Legalelectric, Inc.

April 25, 2025

RE: “NEED” Reply Comment
The Prehn Family & NoCapX 2020
Mankato-Mississippi River Transmission Line f/k/a Wilmarth-N Rochester-Tremval
PUC Certificate of Need Docket CN-22-532

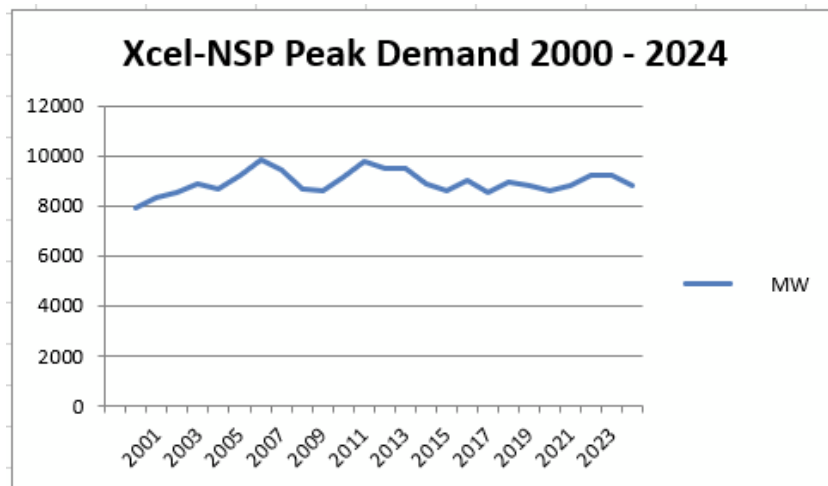
This is important because at 8,822 MW, Xcel's peak demand is down 409 MW from last year. How many AI data centers can operate on 409MW? More importantly, at 8,822 MW, Xcel's peak demand is 1,000MW shy of the all-time high peak demand of 9,859 MW in 2006! How many data centers can operate on that 1,000MW? Why is this important? Xcel is now crying that "demand will go UP, UP, UP!" 2.49% annually as it laughably claimed in the CapX 2005 Technical Report¹⁵.

What does Peak Demand look like over the last 25 years according to Xcel Energy's SEC 10-K filings? Here are the numbers:
